ESPLANADE ESTATES SUBDIVISION

APPLICATION NUMBER 6 DATE September 2, 2021

REQUEST Subdivision

DETAIL SITE PLAN

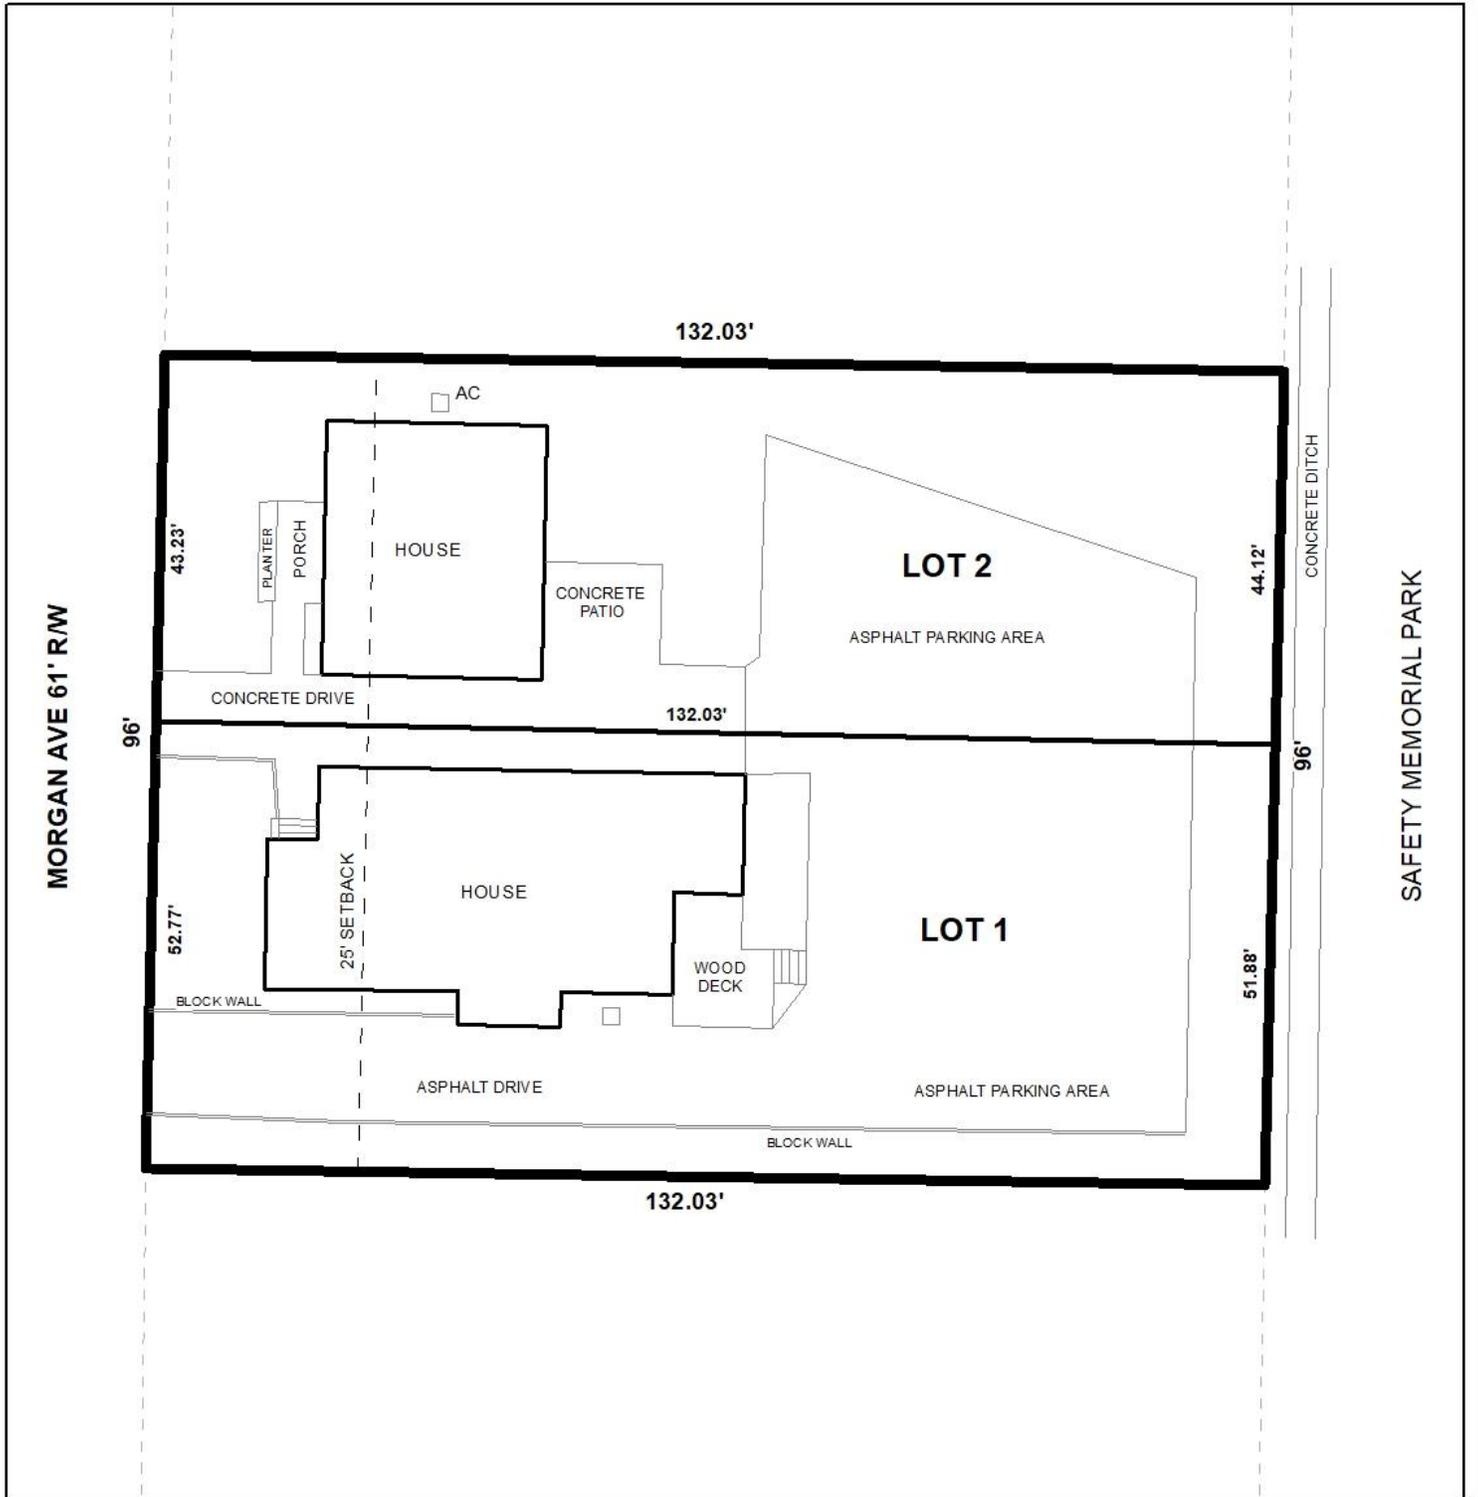
The site has frontage on Morgan Avenue, a minor street with a compliant 61-foot right-of-way; therefore, no dedication would be required. The right-of-way width of Morgan Avenue should be retained on the Final Plat, if approved. Both existing dwellings encroach well into the

required 25-foot minimum building setback line along Morgan Avenue; however, this line should be retained on the Final Plat, and be applicable to any new construction.

Both proposed lots would be of sub-standard size. However, given that the current sizes are both sub-standard, and the proposed common lot line shift would provide further separation between the existing structures, a waiver of Section V.D.2. of the Subdivision Regulations would seem in order. As on the preliminary plat, the lot size labels in both square feet and acres should be retained on the Final Plat, or a table should be furnished on the Final Plat providing the same information.

- 1) retention of the right-of-way width of Morgan Avenue on the Final Plat;
- 2) retention of the 25-foot minimum building setback line on the Final Plat, applicable to any new construction;

- 3) retention of the lot size labels in both square feet and acres on the Final Plat, or the furnishing of a table on the Final Plat providing the same information;
